**BUS PARKING FACILITY – CARTER RESIDENCE
ANDERSON SCHOOL DISTRICT 4
PROJECT NO: 14018
ADDENDUM #1**

December 5, 2014

PROJECT: BUS PARKING FACILITY -
BUILDING RENOVATION
PENDLETON HIGH SCHOOL
ANDERSON SCHOOL DISTRICT FOUR

D101-1

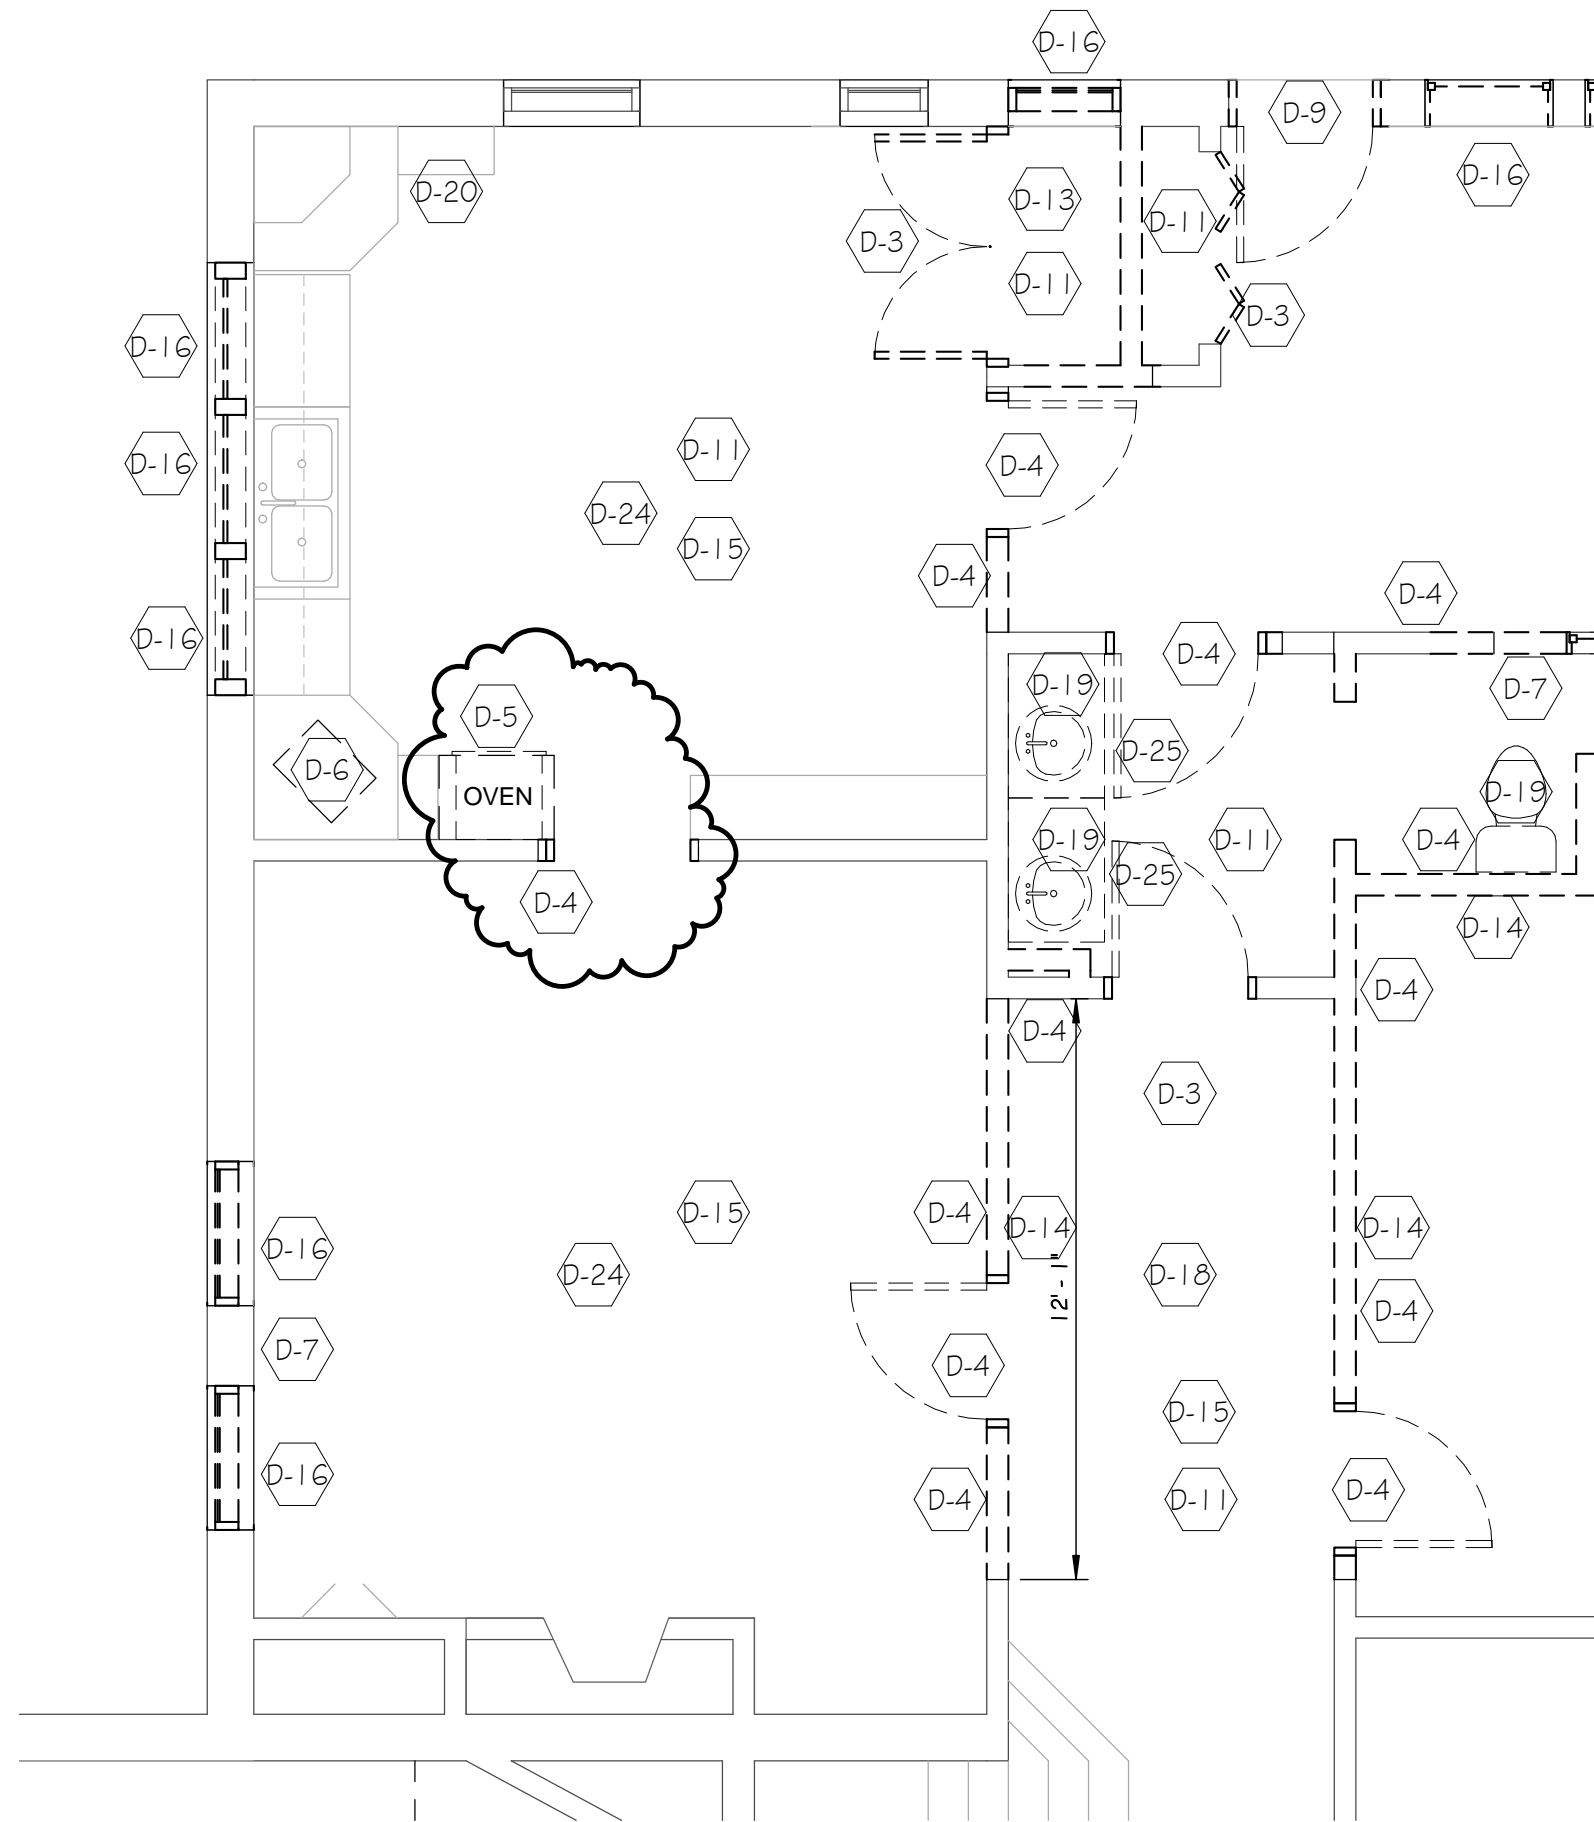
1. **D101** - Add the following general note: "Contractor shall verify condition of all floor joist, subfloor and edge band in crawl space and repair and/or replace any rotted or insect/water damaged wood."
2. **A301** – Add wood door between Meeting Room 7 and Break Room 12. See attached bulletin drawings D101-1, A301-1 and A501-1.
3. **A701** – Detail 1 – the existing 2x structure above the replaced columns shall have the existing metal fascia and structure wrap removed and replaced. The existing roofing of the porch will remain undisturbed.
4. **E201** – See attached bulletin drawing E201.1 indicating revised meter location and disconnect.
